PUBLIC MEETING COMMENT FORM

Proposed Widening of IH-10 (from FM 359 to FM 3538)

Waller and Austin Counties, Texas

MINARY
CHANGE
690+00
695+00
700+00
100' RAIL ROAD
ROW
MISSOURI PACIFIC RAILROAD
PROP ROW
PROP ROW
PROP ROW
CHEW RD
IH 10 EB ERIC RD
IH 10 WB ERIC RD
IH 10 EB MAIN LANES
IH 10 WB TOLL LANES
IH 10 EB TOLL LANES
IH 10 WB MAIN LANES
EAST RD
MATCH LINE STA 710+00

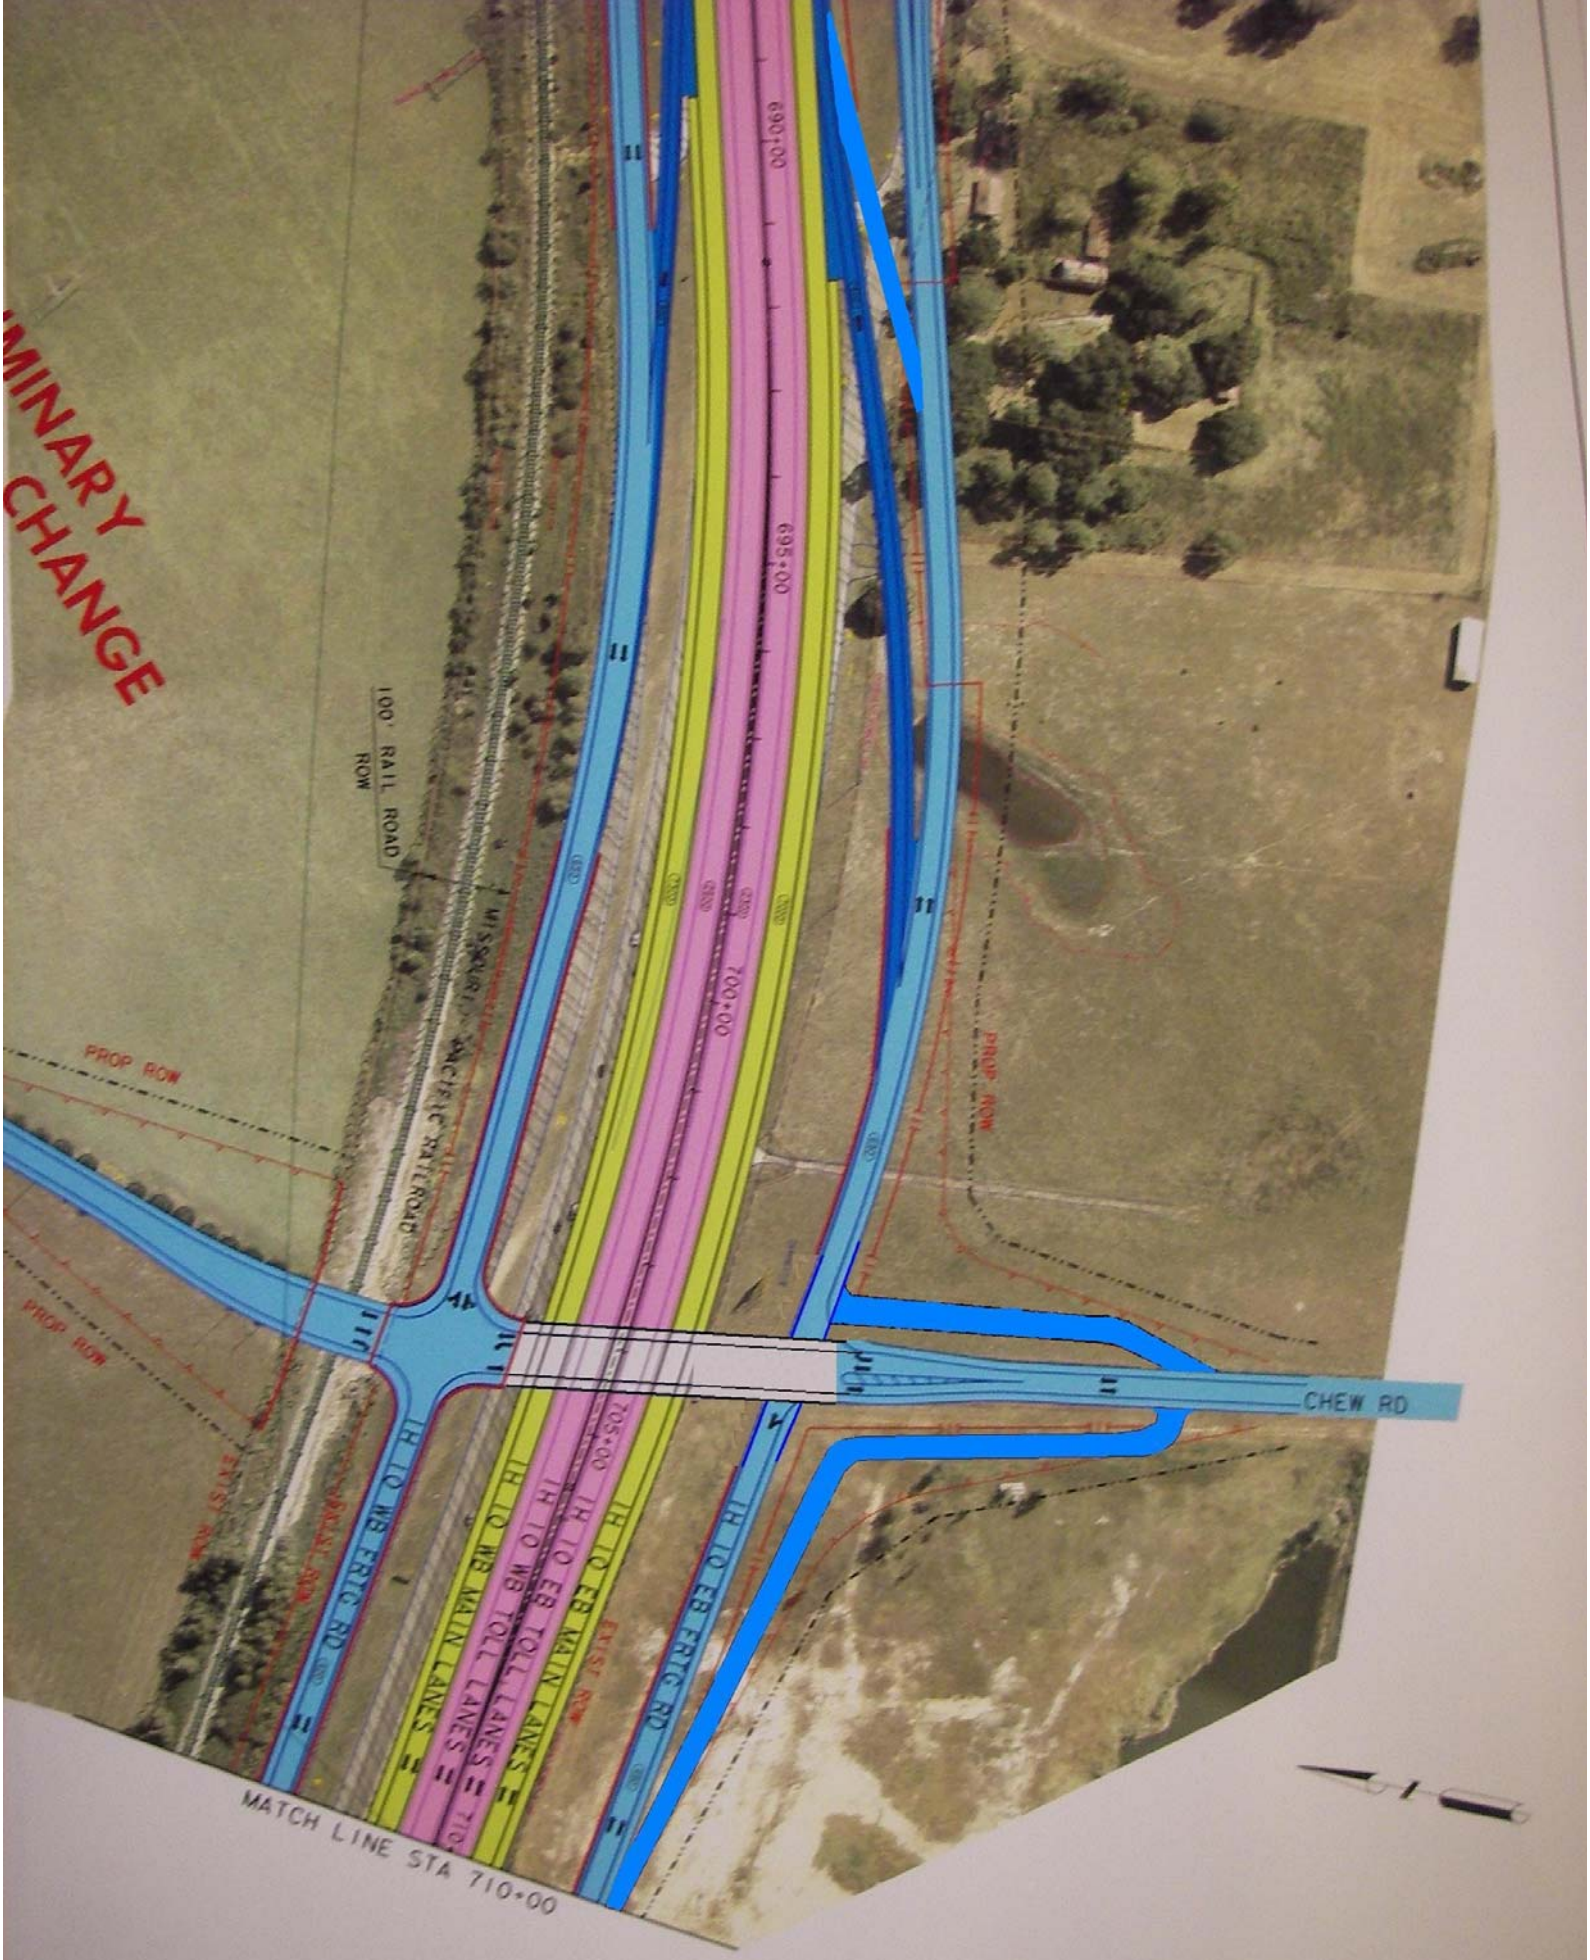
Attachments: MOD.JPG; SCH.JPG
Statement:
There is no reason to elevate the south frontage road at Chew Road Overpass at station 704+20. This design is not the only method to get the traffic off of the frontage road. This design will not provide the frontage to the property that already exists from station 695+00 to station 703+90 in the southeast quadrant of Chew Road Overpass.

I am requesting the department to review this alternative as part of my response to the public hearing process in accordance with TxDOT procedures.
